SLR Project No.: 209.065266.00001

**RE: Environmental Impact Study Addendum for 219 Pegg's Mountain Road,
Township of Armour**

1.0 Environmental Impact Study Comments

1.1 TULLOCH Comments

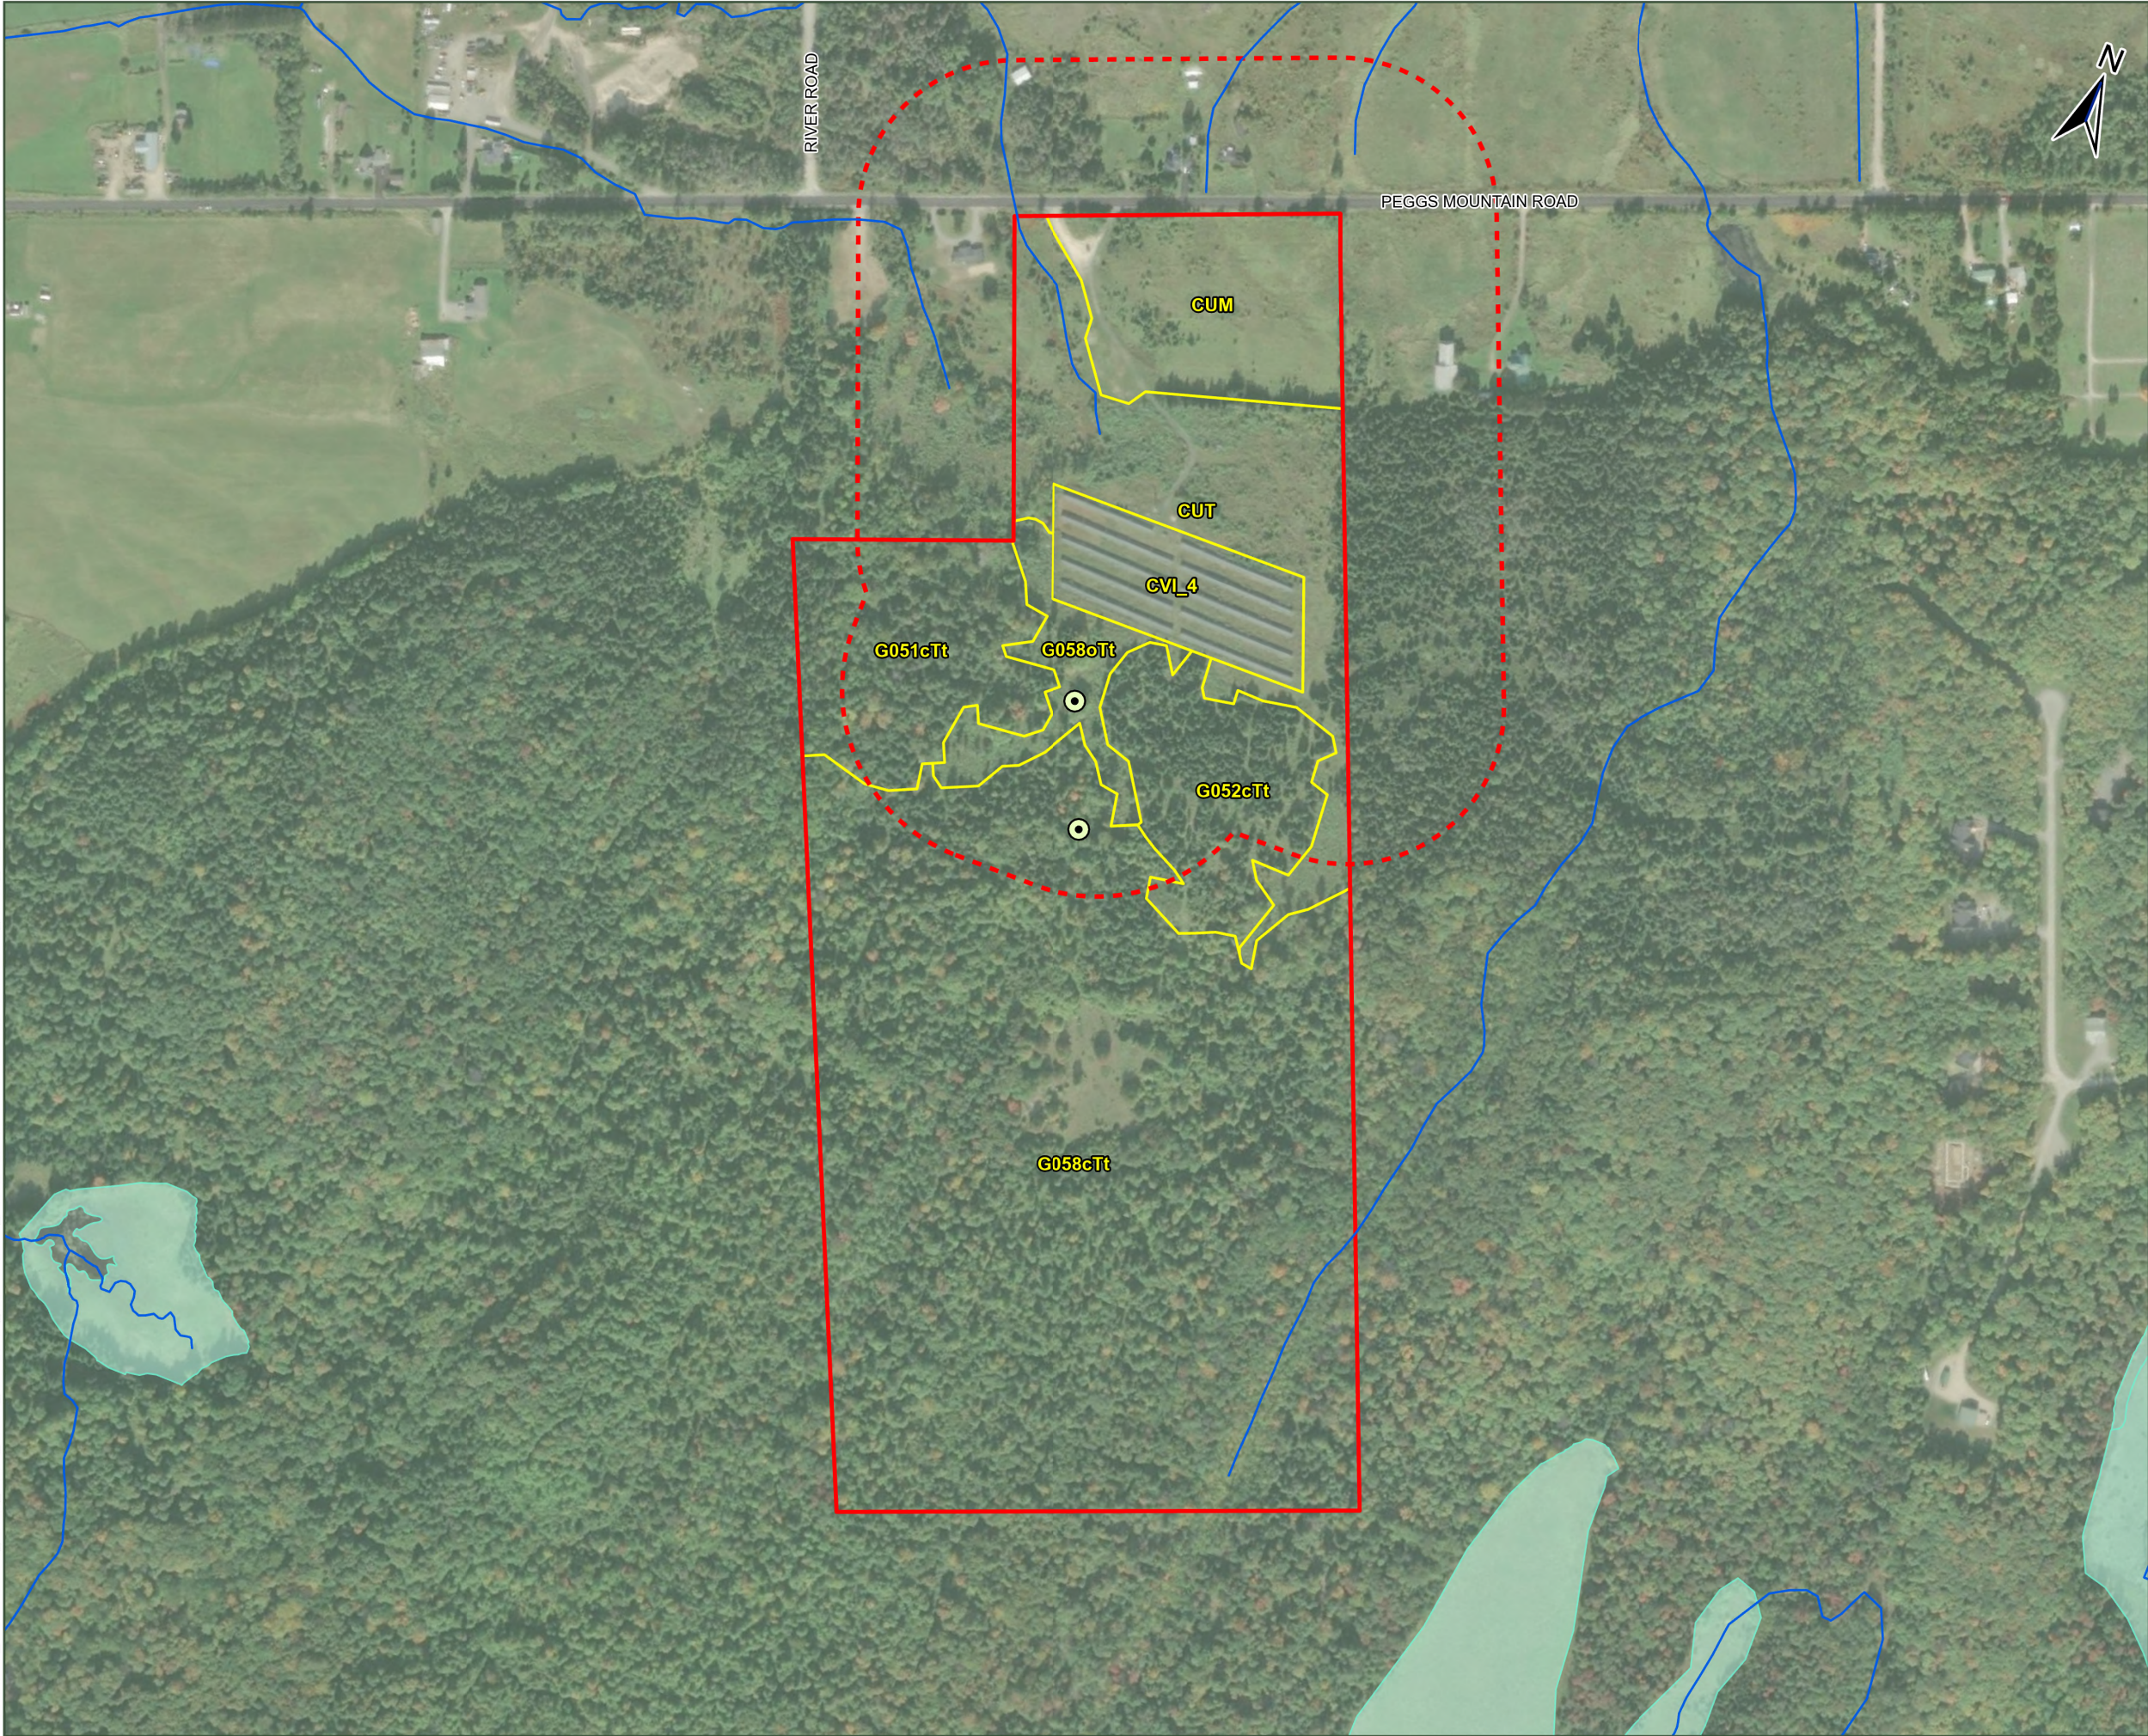
1. *In general, the EIS completed by SLR is well done and well proportioned to the size and scale of the proposed BESS facility.*
 - Acknowledged.
2. *Section 1 states "For the purpose of this EIS, the Subject Property is further subdivided into a Study Area which contains the area of proposed development and the adjacent lands within 120 m of the proposed development." This is an appropriate Study Area. We recommend this area be added to Figures 2 and 3 to illustrate the scope of the study effort on Site.*

- The Study Area (i.e., the area of proposed development and the adjacent lands within 120 m of the proposed development) has been added to Figures 2 and 3 (see Figures attached).
